Responses to CEC Data Requests Set Two: Nos. A124 through A180

Amended Application for Certification
for
HYDROGEN ENERGY CALIFORNIA
(08-AFC-8A)
Kern County, California

**RESPONSES TO DATA REQUESTS A124 THROUGH A180
FROM CALIFORNIA ENERGY COMMISSION (CEC)**

FIGURE A149-1 - SHEET 3

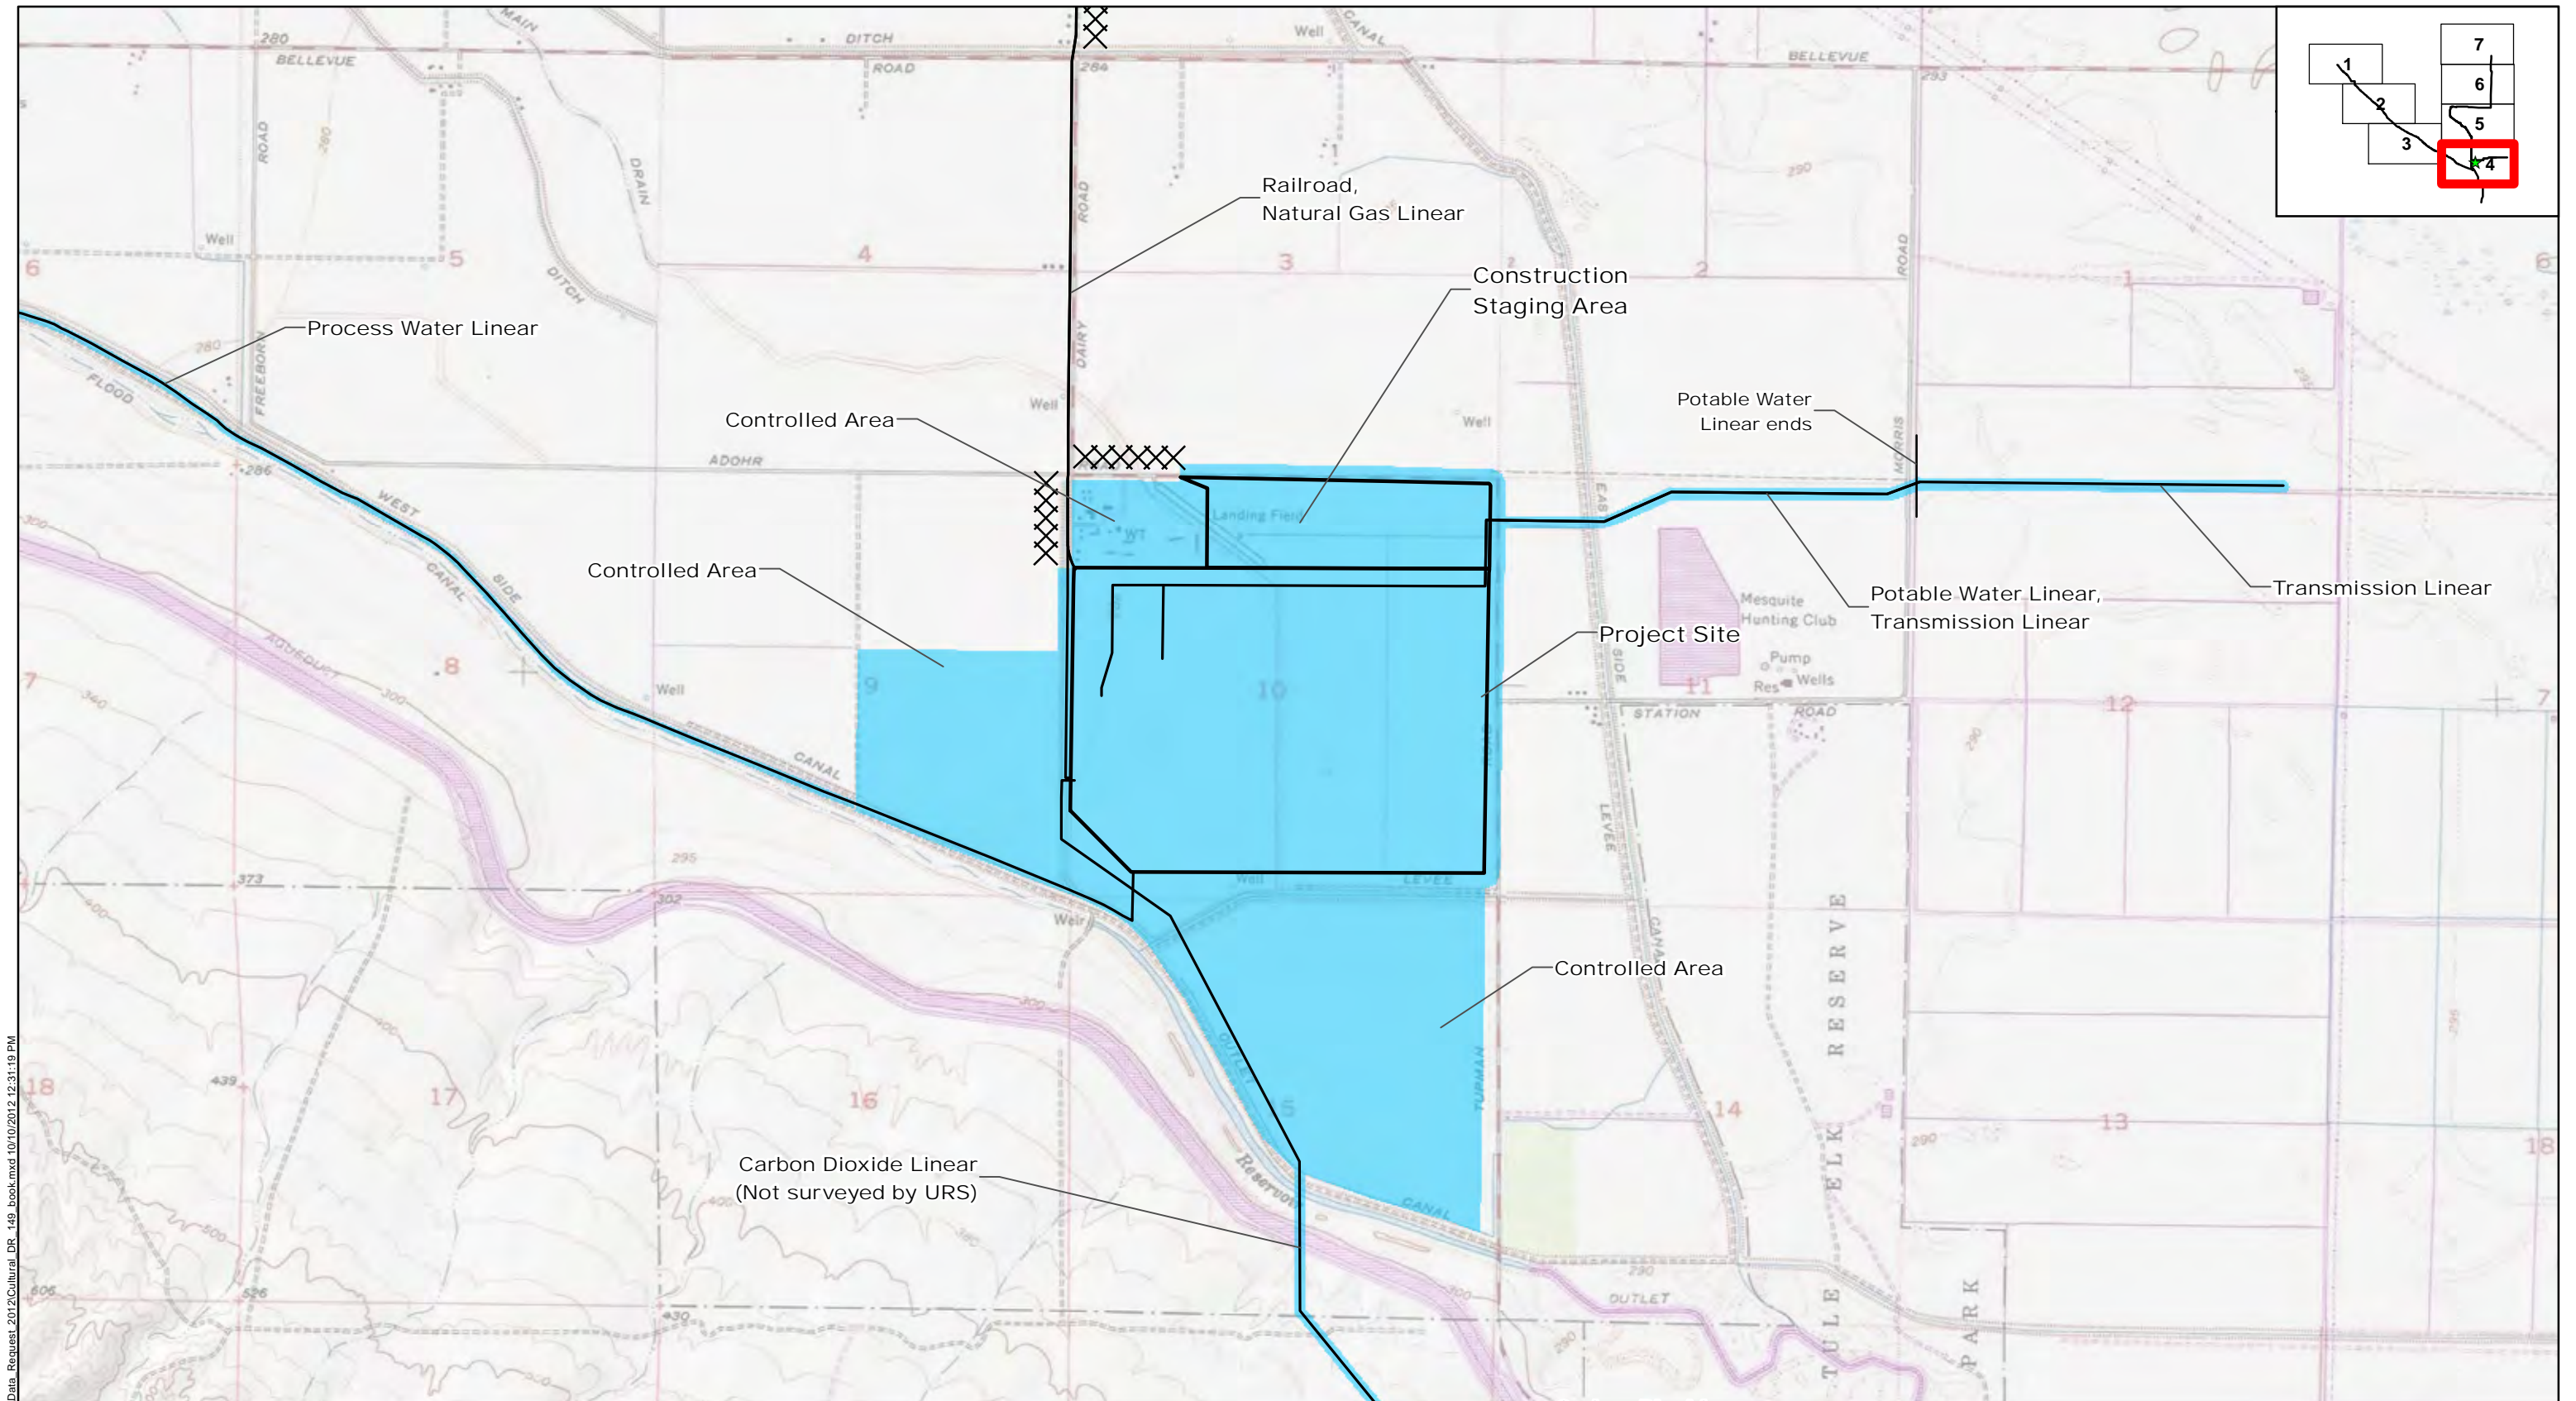
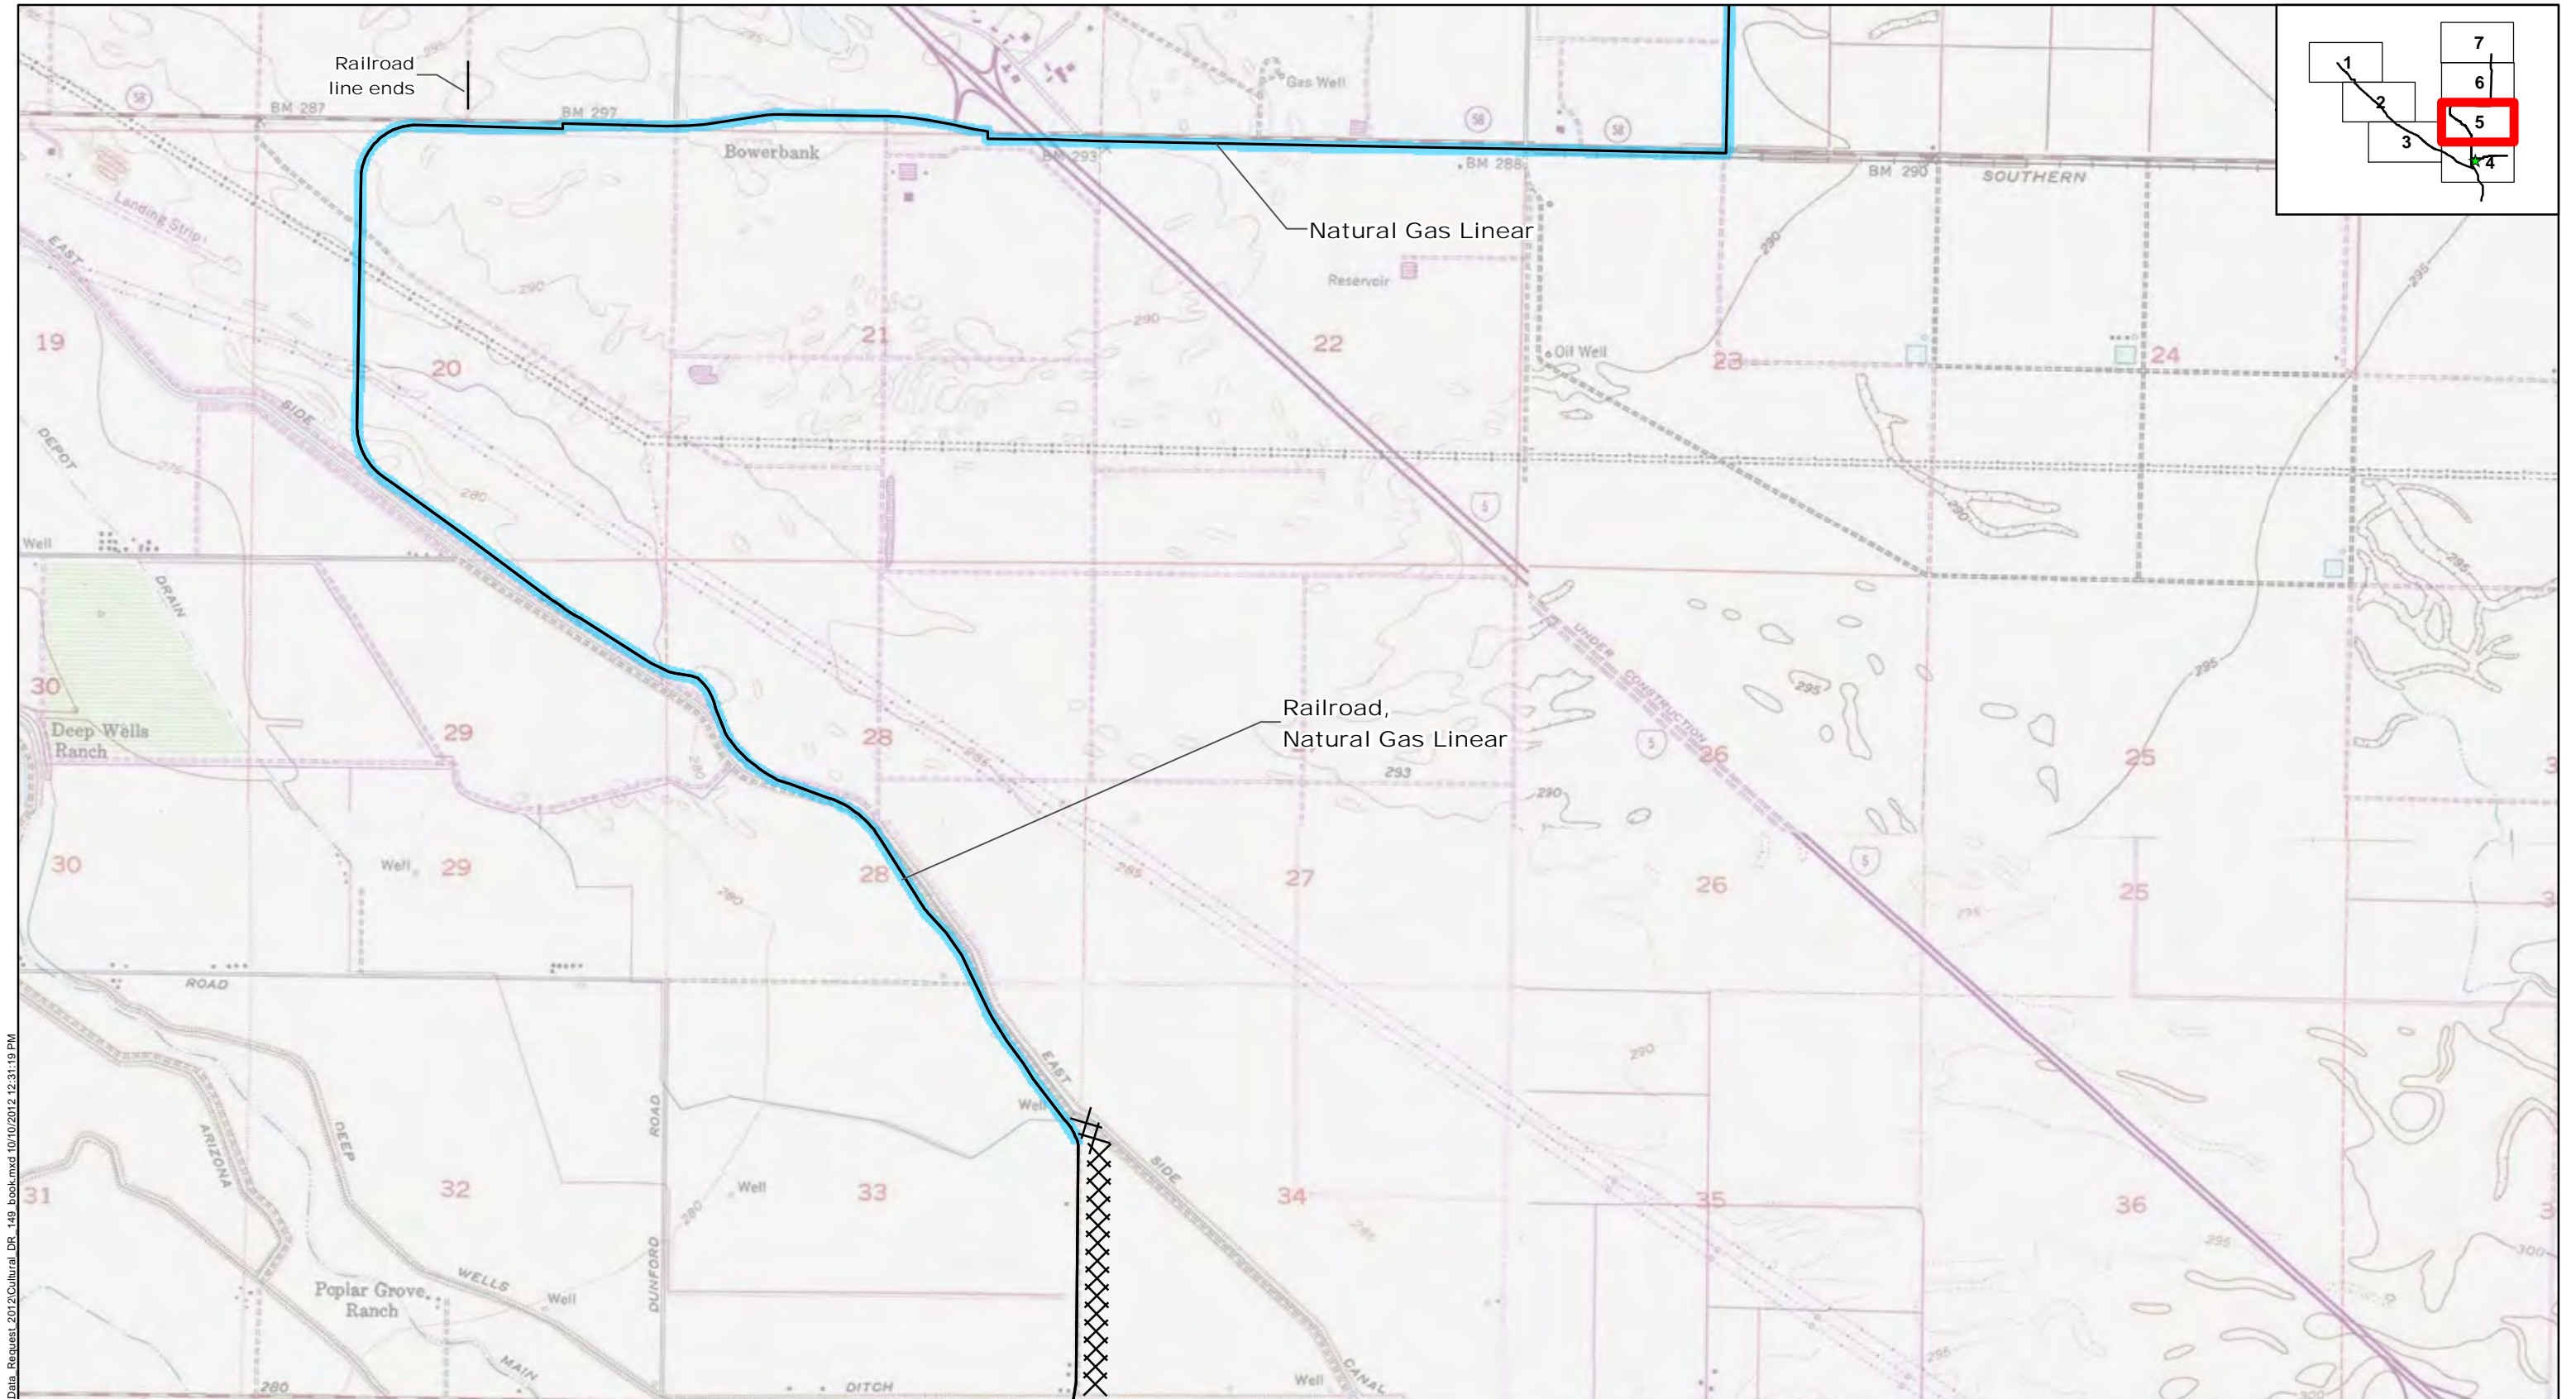
A149. Please provide survey coverage figures on a 7.5-minute topographic quadrangle base (set at 7.5-minute scale). The figures must include all project elements and boundaries of the areas actually surveyed.

A map set depicting all survey coverage on 7.5-minute topographic quadrangles has been prepared, and is presented on Figure A149-1.
